# Access Compliance Report

Intersection ID: 54374	Main Street: GRIER_RD	Cross Street: OLD_CONCORD_RD	Location: E
ADA ID: 9A068604A9F8	Ramp Type: Perp	Initial Pass/Fail: Fail	Overall Compliance: No
Severity Score: 8.75			
Codes/Mitigation Info/Possible Solution		Field Measurements/Component Compliance

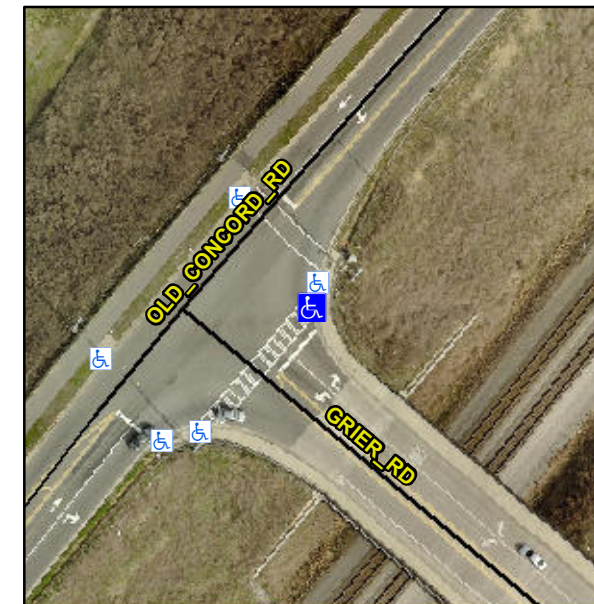
**Not Found, R304.5.1**

Compliance	Description	Data	Compliance	Description	Data
N/A	Ramp Length (in)	82.5	Yes	Ramp Slope (%)	6.4
No	Ramp Width (in)	46.5	Yes	Ramp XSlope (%)	1.0
N/A	Flare Type LT	N/A	N/A	Flare Type RT	N/A
N/A	Flare Slope LT (%)	N/A	N/A	Flare Slope RT (%)	N/A
N/A	Flare Traversable LT?	N/A	N/A	Flare Traversable RT?	N/A
N/A	Landing Length (in)	N/A	N/A	DWS Provided?	N/A
N/A	Landing Width (in)	N/A	N/A	DWS Contrast?	N/A
N/A	Landing Slope (%)	N/A	N/A	DWS Length (in)	N/A
N/A	Landing X Slope (%)	N/A	N/A	DWS Full Width?	N/A
N/A	Landing Curb? (Y/N)	N/A	N/A	DWS Offset (in)	N/A
N/A	Shared Landing?	N/A			
N/A	Gutter Ponding?	N/A	N/A	Gutter Slope (%)	N/A
N/A	Gutter Lip Ht (in)	N/A	N/A	Gutter X Slope (%)	N/A
N/A	Painted X Walk1?	Yes	N/A	Painted X Walk2?	N/A
	X Walk 1 Direction	To SW		X Walk 2 Direction	N/A
N/A	X Walk 1 Width (in)	103.5	N/A	X Walk 2 Width (in)	N/A
	X Walk 1 Slope (%)	0.3		X Walk 2 Slope (%)	N/A
	X Walk 1 X Slope (%)	1.1		X Walk 2 X Slope (%)	N/A

**Remove & Replace Entire Ramp.**
